Engine cover insulation on F53 Chassis

Bulletin Type:	Safety Recall	Publication Date:	December 28, 2020
Bulletin #(s):	20V-667 US Units 2020-531 Canadian Units	Make(s):	Jayco Entegra
Job Code(s):	9903527	Model(s):	Alante, Emblem, Vision, Vision XL, Precept and Precept Prestige
Flat Rate(s):	9903527A-Install Kit A & B - 2 Hr. 9903527B- Install Kit B - 1 Hr.	Model Year(s):	2020 and 2021

Incident:	Engine covers installed on some F53 chassis models do not contain appropriate insulation.	
Affected Units:	Affected unit list is located at end of instructions	
Parts Kit: 20V-667A 20V-667B	Parts Kit 20V-667A: 1 molded foam insert 6' foam seal 4 bolts Parts Kit 20V-667B : 20 screws, hex washer .25x1.25 TEK3 1 molded foam floor insert 22.75" 1 molded foam floor insert 29.5" 2 brackets 1.00x2.31x3.00 14 GA Black 1 bracket 1.00x2.31x20.00 14 GA Black 1 plate 2.00x20.00 14GA Black Please confirm what kit/s are required per serial number using the worksheet posted on Partners.	
Misc. Tools & Supplies:	5/16" socket driver

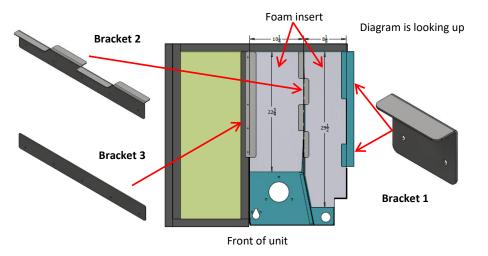
You will need to remove a cable and a line of conduit running across the floorboard panel so that you are able to install the foam insert(s). Using a screw gun and 10mm socket driver, remove the screws that are holding the cable bracket in place. You may need the 10mm open end wrench to hold the screw cap in place while removing the screw. Let both lines drop; you will re-install these in a later step. Discard the screws.

Bracket and Foam Installation Configuration

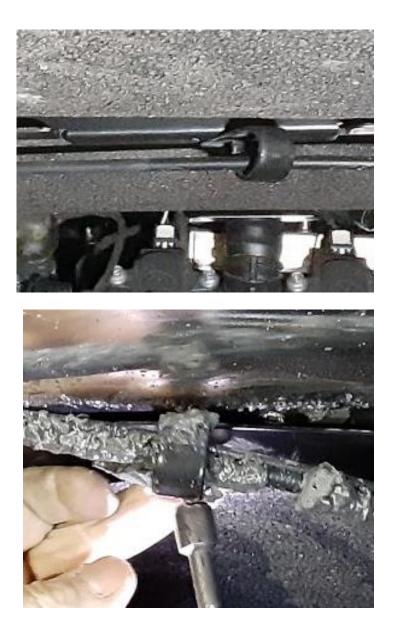
5. Using the self-tapping screws, install the (2) 2.31"x 3.0" brackets on the inside of the floorboard pan (side closest to the engine) using the pre-drilled holes in the bracket. The bracket "lip" should be installed towards the inside of the pan (this will hold the foam insert in place). Install (1) bracket on each side of the indentation in the floorboard pan. The top of the bracket should be against the top of the pan.

Install the 29.5" foam into the floorboard pan. The (2) brackets you just installed will secure the one side of the foam insert. Before installing the insert, make sure the angles and notch are in the right place according to the shape of the pan.

7. Using the self-tapping screws, install the 2.31" x 20.0" center bracket (bracket 2 in the diagram) using the pre-drilled holes. Inure the bracket is centered in the middle of the pan frame. The bracket lip will secure the edge of both foam inserts.
